## **Informational FIELD SERVICE BULLETIN**

FSB Number: LVCCFSB2006-163  
Author: Tony Bryan  
Date: April 24, 2006  
Total No. of Pages: 2  
Subject: GSM PEBL U6 – RoHS Compliant Flip Screws  
Model Affected: GSM PEBL U6  
Level of Repair: INFORMATION ONLY

Flip-Outer Housing  
Revision Marking  
"D"

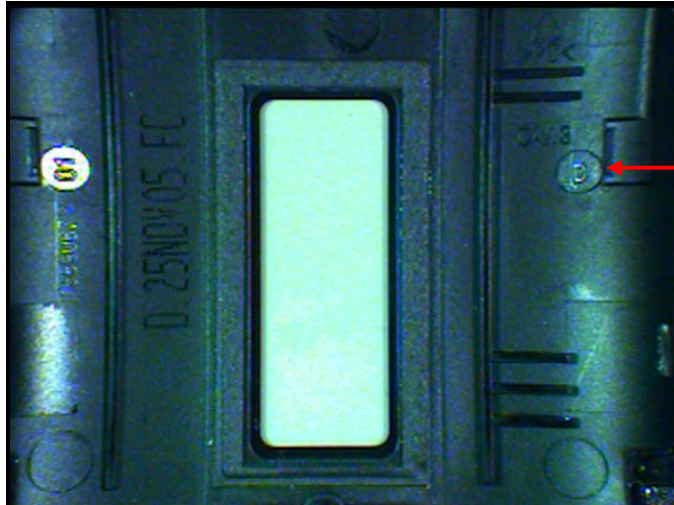
This is an informational field service bulletin to communicate that the GSM PEBL U6 flip assembly has been updated with RoHS compliant screws. The part number for the two bottom flip screws has changed from 0389064Y01 to 0389064Y02. The new screw finish used on the Y02 screw required a tooling change to the Flip-Outer Housing 1589151Y02. The revision of the Flip Outer Housing 1589151Y02 has changed from Rev. D to Rev. E to support the new Y02 screw. This change was initiated in the factory as of March 31, 2006.

Service should use the information provided below identify these units in the field. The flip outer rev marking is easily seen on core side of housing. See Image Below.

- IF Rev D, use Y01 screw for re-assembly
- IF Rev E, use Y02 screw for re-assembly.
